**TOWN OF BROOKLYN
PLANNING AND ZONING COMMISSION
Regular Meeting Agenda
Tuesday, March 21, 2023 6:30 p.m.**

- a. Reading of Legal Notices:
 - b. Continued Public Hearings:
 - 1. **SP 22-008:** Special Permit Application for Multi-Family Development (50 Condominium units) on south side of Louise Berry Drive (Assessor's Map 33, Lot 19), 13.5 acres, R-30 Zone, Applicant: Shane Pollack and Erin Mancuso.

**TOWN OF BROOKLYN
PLANNING AND ZONING COMMISSION
Regular Meeting
Wednesday, March 1, 2023 6:30 p.m.**

NORMAND THIBEAULT, JR., P.E. No. 22834 DATE

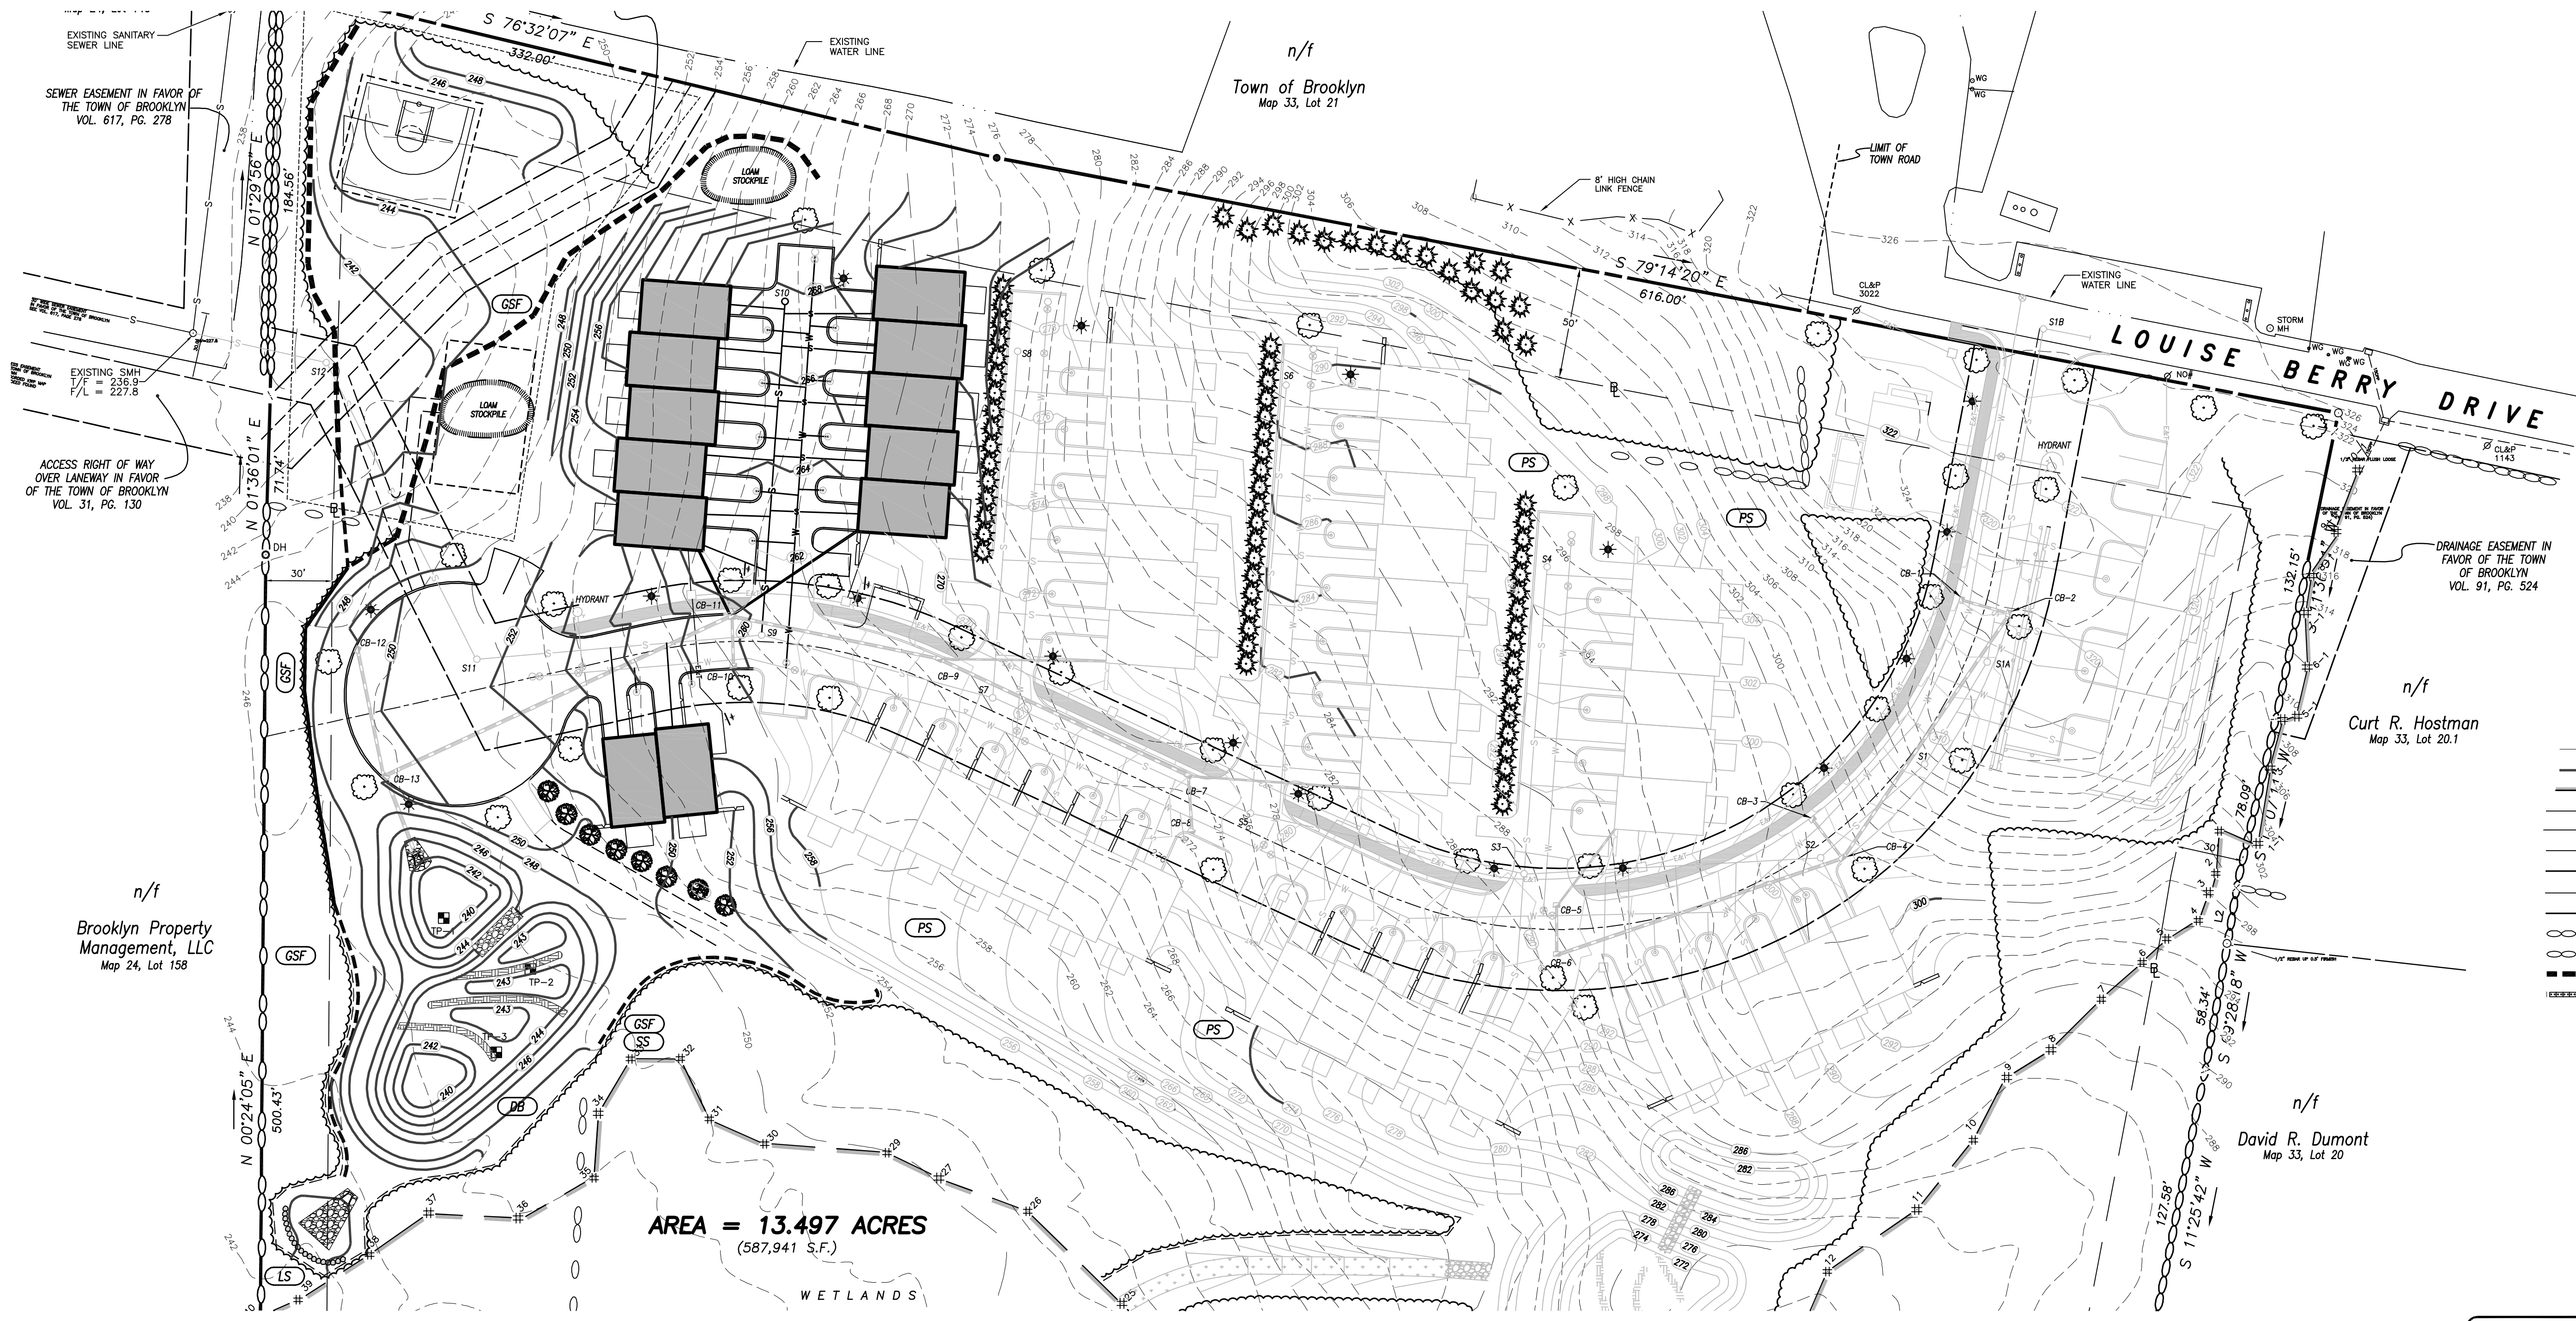
#1 - They are showing every phase to be paved. The sequence of construction on the Detail Sheet shows that the final course of paving will be installed upon completion of each phase.

#2 - They shaded the sidewalk areas on the phasing plans to make them more visible.

#3 - They added tree plantings to the phasing plans.

#5 - They added on-street parking to the phasing plans.

#6 - They added road centerline to the phasing plans.

#7 - They added stockpile areas to the phasing plans.

#8 - The proposed contour lines for the phases are a result of the final paving. He explained that there is a transition between phases as those contours have to be tied-into existing grades. He said that, for the most part, the contours are consistent with the overall plan.

Sheet 13 of 16 - Detail Sheet 1

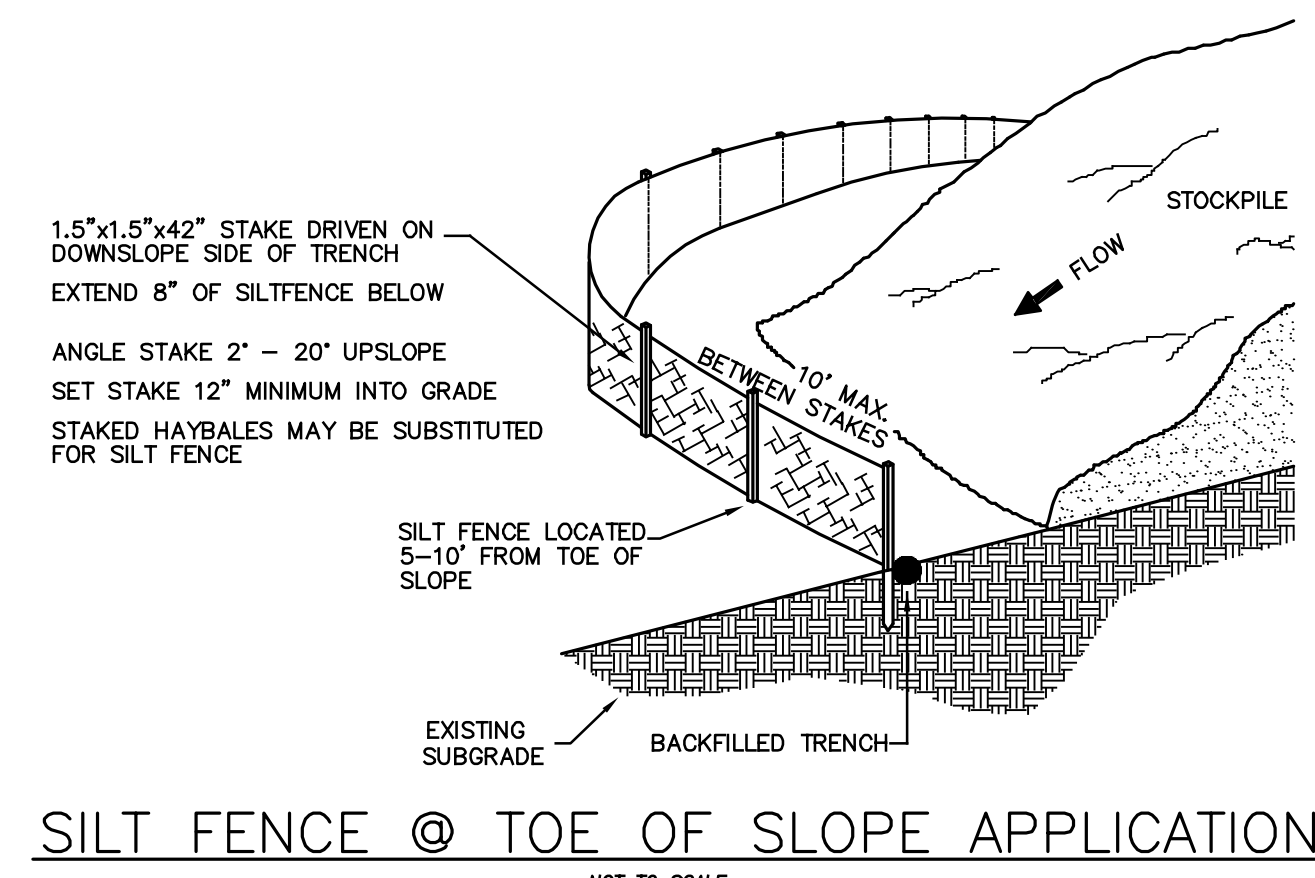
#10 - Mr. Thibeault said that this note has been added to the sequence of construction that the final course of pavement will be installed at the completion of each phase.
